**CITY OF HAMILTON**

<b>TO:</b> Chair and Members Planning Committee	<b>WARD(S) AFFECTED:</b> WARD 5
<b>COMMITTEE DATE:</b> April 16, 2013	
<b>SUBJECT/REPORT NO:</b> Heritage Permit Application HP2013-008, Under Part V of the <u>Ontario Heritage Act</u> , for Erection of a Structure at 920 Beach Boulevard (Hamilton) (Ward 5) (PED13070)	
<b>SUBMITTED BY:</b> Tim McCabe General Manager Planning and Economic Development Department	<b>PREPARED BY:</b> Alissa Golden (905) 546-2424 Ext. 1214
<b>SIGNATURE:</b>

Proposed Site Plan  
916 and 920 Beach Boulevard

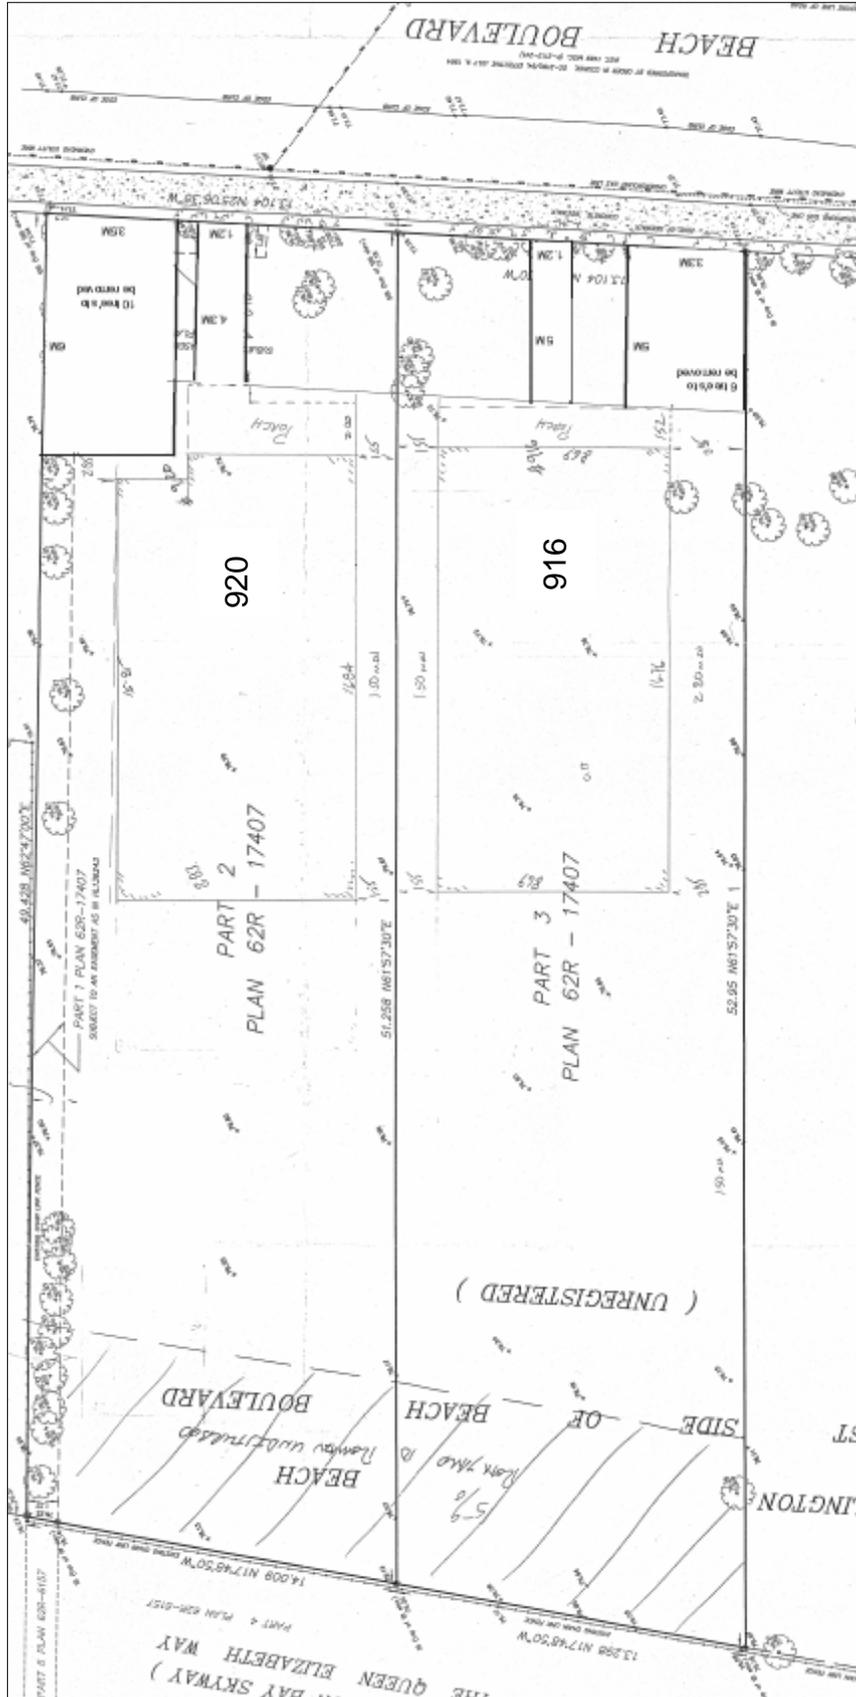
Displacement: The subject property is currently vacant except for various trees and vegetation and a concentration of trees towards the front and north side of the lot. Staff notes that the trees of along the front (east) lot line will be removed to accommodate a driveway and facilitate development of the site. The site plan proposed as part of this Heritage Permit application does not address the grading-related impacts to the existing trees and vegetation on site (see Appendix “D”). The proposed driveway and walkway in the northern corner of the front of the lot appear to impact ten existing trees.

Staff recommends that a plan be prepared depicting the removed, retained, and new trees, including the caliper size, locations, and species, to the satisfaction and approval of Planning staff, prior to any grading or tree removals. Alternative configurations of the proposed driveway and walkway should be considered to retain as many existing trees as possible. A minimum of one replacement tree of minimum caliper of 55mm of a species consistent with the City of Hamilton’s Tree Species and Recommended Use Index should be planted within one year of occupancy of the new dwelling. These conditions will help ensure the suitable retention of existing trees and the planting of new trees, where feasible (see Recommendations (c) and (d)).

The proposed walkway and driveway are to be constructed with concrete. At the pre-submission review of this application on January 23, 2013, the HPRS recommended using different materials for the driveway and walkway, respectively. The drawings have not been revised to reflect this change. Staff recommends that the final drawings should be submitted, to the satisfaction and approval of Planning staff, prior to submission as part of any application for a Building Permit (see Recommendation (a)).

- (c) That as many existing trees as possible shall be retained, and that a minimum of one replacement tree of a minimum caliper of 55mm of a species consistent with the City of Hamilton's Tree Species and Recommended Use Index shall be planted within one year of occupancy of the new dwelling;
- (d) That a plan depicting the removed, retained, and new trees, including the caliper size, locations, and species, shall be submitted, to the satisfaction and approval of Planning staff, prior to any grading or tree removals; and,
- (e) That construction and site alterations, in accordance with this approval, shall be completed no later than March 31, 2015. If the construction and site alterations are not completed by March 31, 2015, then this approval expires as of that date, and no alterations shall be undertaken without a new approval issued by the City of Hamilton.
